HX-2706B

NAME	ATQ-2716	MATERIAL	PM-9823	SCALE	1:1	ANGLE	±1°
DRAWING NO.	HX-2706B	PIN MATERIAL	CP WIRE	UNIT	m/m	REV.	01
<p>东莞市华欣塑胶制品有限公司 DONGGUAN HUAXIN PLASTIC MANUFACTURING PRODUCTS CO., LTD. TEL: 0769-86388088 86388188 86388288 FAX: 0769-86388111 http://www.hxbobbin.com E-Mail: hxbobbin@vip.163.com</p>		TOLERANCE OF PIN DIA ±0.05				UL REC.: 94V0	
		PIN TENSION LOAD kg MIN		TOLERANCE: 0<L<4: ±0.1 4<L<16: ±0.2 16<L<63: ±0.3			
DRAWN & DRAFTED BY		LIN HUA JING		CHECKED & APPROVED BY		DATE: AUG 26 2017

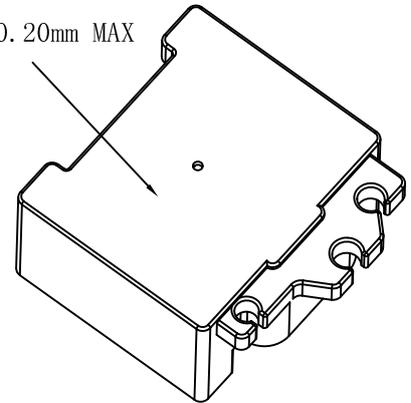
此平面平贴度0.20mm MAX

REV.	REVISION RECORD	DATE	REV	REVISION RECORD	DATE
01	增加底部平贴度管控0.20mm MAX要求	2023/08/24	03		
02			04
